Summary of the Project		RFI 22/03/2024
6 Sleigh Place, Wetherill Park NSW 2164		DA 350.1/2023
<p>Increase from 29,500 tonnes per annum (tpa) to 65,000 tpa, by extending operating hours to 24/7, comprising:</p> <ul style="list-style-type: none"> <li>Stormwater/GPT material: 60,000 tpa (30,500 tpa increase)</li> <li>Wood waste (sawdust): 1,000 tpa (input to aid processing)</li> <li>Street sweeper waste: 4,000 tpa (as approved).</li> </ul> <p>Residuals analysis in accordance with EPL #20694 and EPA Waste Classification Guidelines, then:</p> <ul style="list-style-type: none"> <li>Disposed to appropriate landfill</li> <li>GSW CT1 to beneficial reuse (in accordance with Classification &amp; Resource Recovery Order if suitable) and;</li> <li>Treated and discharged to sewer in accordance with Sydney Water Trade Waste Agreement.</li> </ul>		<p>Mainstream Recycling has formally withdrawn the 4,000 tpa street sweeping waste component from its application (29 March 2024). Amended proposal comprises:</p> <ul style="list-style-type: none"> <li>Stormwater/GPT material: 64,000 tpa (30,500 tpa increase)</li> <li>Wood waste (sawdust): 1,000 tpa (input to aid processing).</li> </ul> <p>No other chang

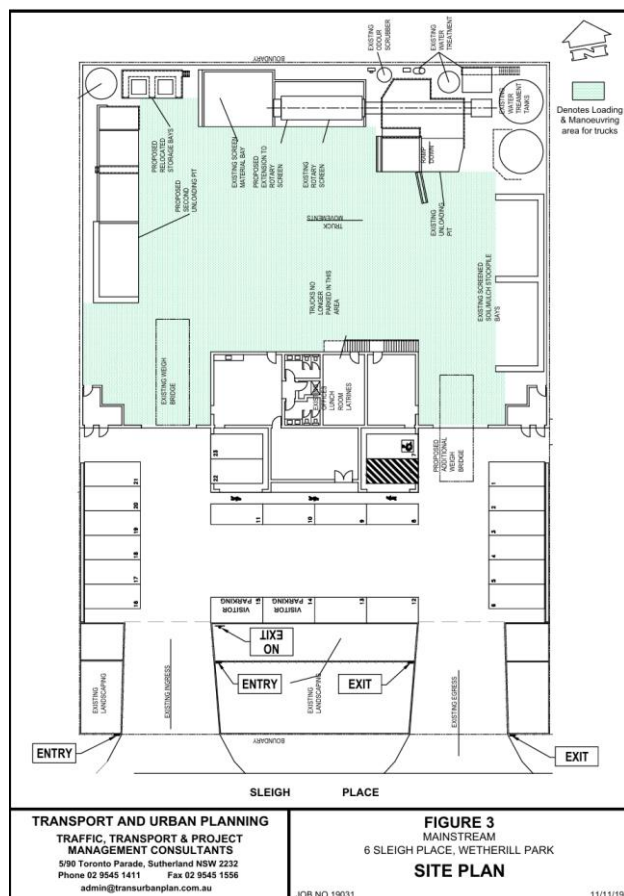
<p>An assessment of the application has revealed the submitted Architectural Plans contain insufficient information. Amended Architectural Plans shall be submitted to Council which address the following deficiencies:</p>	<p>The facility at 6 Sleigh Place Wetherill Park has twenty three (23) car parks, of which two (2) are allocated to visitors (see numbers 15 &amp; 15, Figure 3, Traffic &amp; Transport Assessment Report for Proposed Additional Capacity and Increased Hours of Operation for Gross Pollution Trap Facility (Transport &amp; Urban Planning, Appendix I).</p> <p><b>The intended purpose/use of the two (2) boxes located immediately west of the first weighbridge.</b></p> <p>As attached, the two boxes represent a sedimentary system to which drains to a sump. A pump contained in a 3mm perforated steel mesh sump pumps to the water treatment plant.</p> <p><b>The capacity of the two (2) water treatment tanks located in the north eastern corner of the building.</b></p> <p>Each tank has a maximum 80kL capacity. Water level sensors are located within the tank and has ability to trigger a 24hr monitored back-to-base security control room. Currently set to 60%.</p> <p><b>The capacity of the unloading bay and soil/mulch stockpile bays.</b></p> <p>The unloading bay has a 60m<sup>3</sup> capacity. The soil/mulch stockpile has a 92m<sup>3</sup> per bay (x2) capacity.</p> <p><b>The dimensions of both of the weighbridges.</b></p> <p>The dimensions of each weighbridge are 10m X 3.5m. Each weighbridge has the ability to split axle weight for multi-trailer vehicles, hence all vehicles required for the Facility can be electronically weighed and recorded entering and exiting. Note that the above Management Plans provide detailed procedures for weighing and recording each load, stored to the cloud and monitored by CCTV.</p>

<p>In addition to the above, an assessment of the application has revealed a number of discrepancies within the documents submitted to Council. The Applicant shall provide clarification regarding the following:</p> <ul style="list-style-type: none"> <li>• Reference is made within the application to reduce the number of accessible car parking spaces from two (2) to one (1). However, the submitted Architectural Plans indicate car parking spaces no. 6 and 7 are accessible parking spaces.</li> </ul>	<ul style="list-style-type: none"> <li>• During assessment of the Facility for the preparation of the Traffic &amp; Transport Assessment Report for Proposed Additional Capacity and Increased Hours of Operation for Gross Pollution Trap Facility (Transport &amp; Urban Planning, Appendix I), it was noted that the accessible car spaces had not been used for their intended purpose since commencement of site operations in 2015, hence the request to reduce these from two to one space. These spaces (No's 7 &amp; 8) on the submitted architectural plan, are an inconsistency in our documentation. The correct number of car spaces are shown in Figure 3 in the Traffic Report Appendix I (car space No 7). No off-site car spaces are required.</li> <li>• As above, the correct number of car parks at 6 Sleigh Place is twenty three (23), not twenty four (24).</li> </ul>

<ul style="list-style-type: none"> <li>Reference is made within the application that there are car parking spaces for twenty-three (23) staff and two (2) visitors. However, the submitted Architectural Plans indicate there are twenty-four (24) car parking spaces.</li> <li>Figure 3.6 - Site Operations Plan, of the submitted Environmental Impact Statement, prepared by Mainstream Recycling, dated November 2023, appears to be outdated and reflects the previous layout of the site.</li> </ul>	<ul style="list-style-type: none"> <li>We acknowledge and apologise: Figure 3.6 - Site Operations Plan, of the submitted Environmental Impact Statement, prepared by Mainstream Recycling, dated November 2023, is outdated. Plans will be updated and corrected as part of the review of the Operations and Waste Management Plans.</li> </ul>
<b>Environment Protection Authority (EPA) Referral</b>	
<p><b>Further Information Required:</b> The information provided regarding the waste including the waste management and handling procedures is at a minimal level and is not sufficient. The EPA expects detailed information to be provided for an application of this nature to be able to adequately assess the environmental impacts. The supporting documentation provided with the DA contains minimal information regarding the waste type and waste management and handling procedures of <b>street sweeper waste</b>. It is insufficient and the EPA expects detailed information to be provided with an application of this nature.</p>	<p>Mainstream Recycling has withdrawn the street sweeping waste component from its application.</p>

Figure 3: Traffic & Transport Assessment Report for Proposed Additional Capacity and Increased Hours of Operation for Gross Pollution Trap Facility (Transport & Urban Planning, EIS Appendix I). This set out the twenty three (23) car spaces on site. Note also DDA car spaces (No 7) and visitor car spaces (no's 14 & 15). No off -site car parking proposed or required.
